Compliance with State Environmental Planning Policy (SEPP) 65 - Design Quality of Residential Apartment Development

A design statement has been prepared by the project's registered architect. The statement addresses each of the 9 'design quality principles' listed under schedule 1 of SEPP 65. In determining an application, a consent authority must take into consideration the design quality of the residential apartment development when evaluated in accordance with these 9 design principles. The 9 principles are listed below, together with a town planning response. (Note: SEPP 65 does not apply to the business/retail component of the development).

L001 LANDSCAPE - GROUND FLOOR PLAN

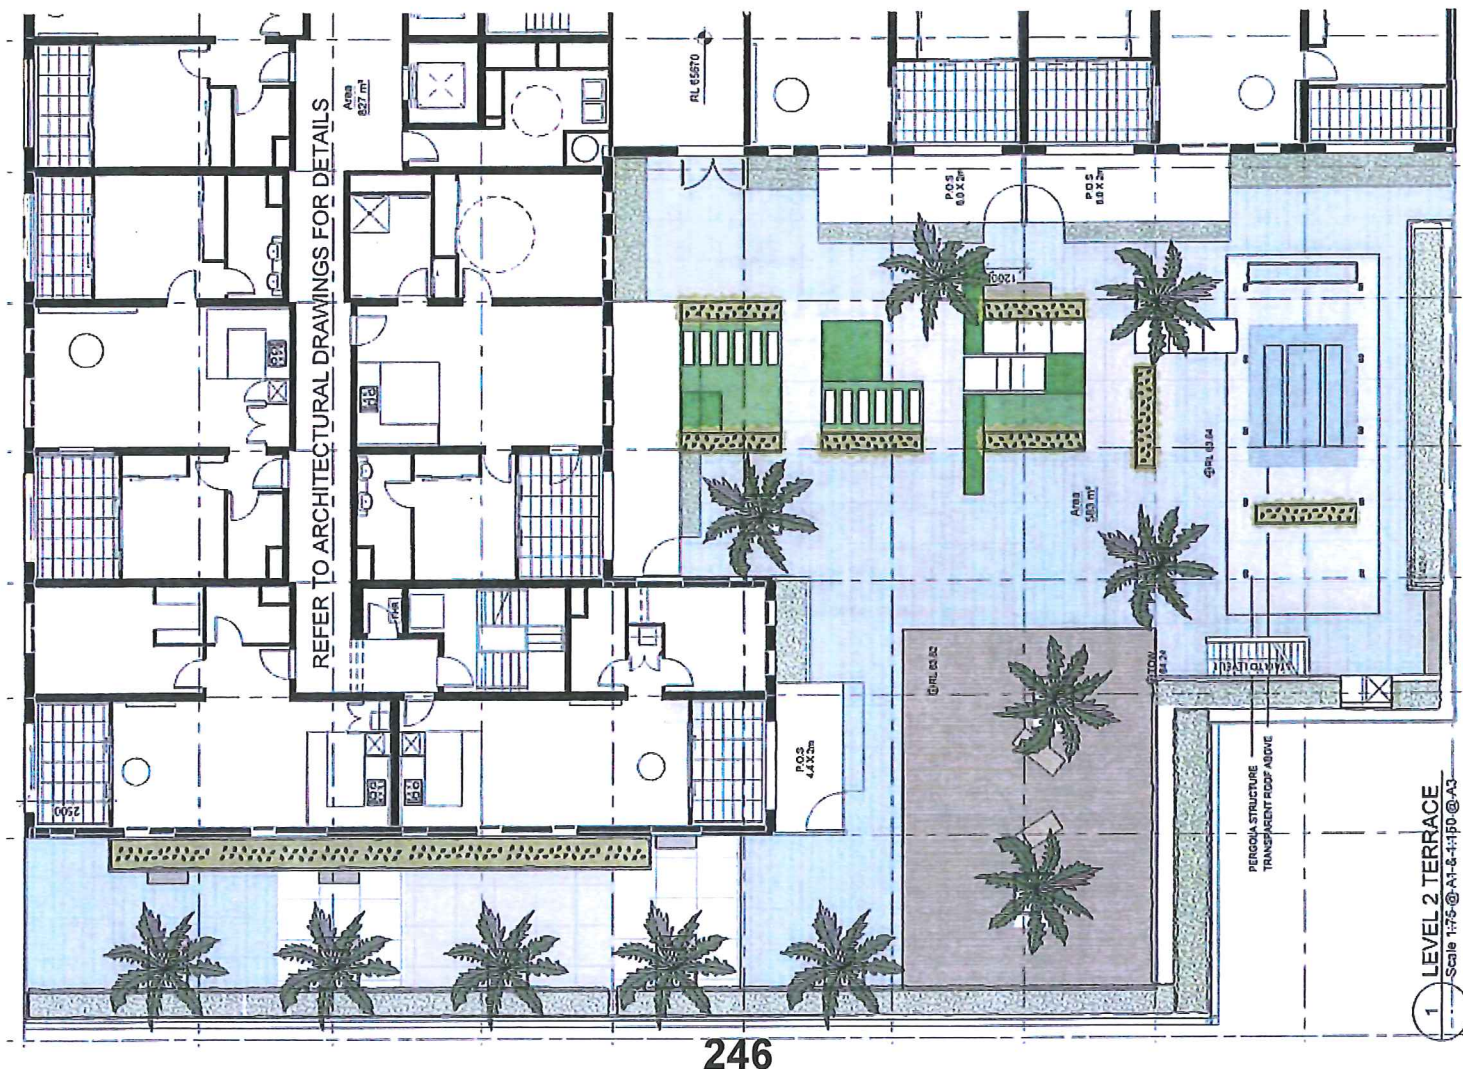
4O Landscape design site area < 850 sqm - 1 medium tree per 50 sqm of deep soil zone. 850 sqm to 1,500 sqm - 1 large tree or 2 medium trees per 90 sqm of DSZ. >1,500 sqm - 1 large tree or 2 medium trees per 80 sqm of DSZ.	The site area is 2,111 sq m. There are no deep soil zones given the podium extends to all 4 boundaries. Planter boxes with appropriate landscaping will be provided at the podium level. Additional planter boxes and planting is provided to the north and east elevations.	Satisfactory
4P Planting on structures Provide suitable plant selection. Provide suitable irrigation and drainage systems and maintenance. Enhance the quality and amenity of COS with green walls, green roof and planter boxes, etc.	Limited planting is provided on the podium. It is provided in 600mm high concrete boxes. The landscape design is considered suitable for a mixed-use development in the CBD.	Satisfactory
